# Customer Product Bulletin - #CPB-1202

Doc. #3000289.1

## Maxwell BMOD0165 P048 BXX – Continuous Improvements

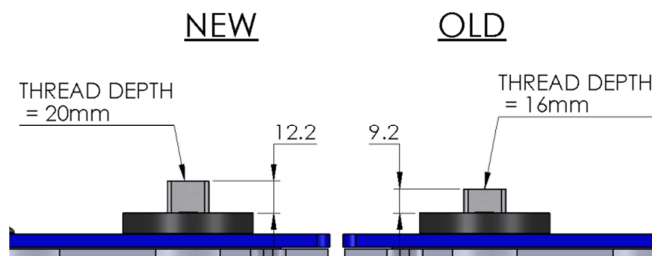
Change #1: BMOD0165 P048 BXX all 48V modules with manufacturing date codes 12353 and newer. P/N 108657B is superseded by P/N 129323.

Through continuous improvement efforts, Maxwell has determined that a minimum of 20 mm of thread depth on the 48V module electrical terminals is optimal for ideal product performance. This change does not affect form, fit or function, maximum height is unchanged at 179 mm as defined on the product data sheet.

1. The M8 and M10 Terminals have increased in height by 3.0mm to accommodate the thread depth requirement.
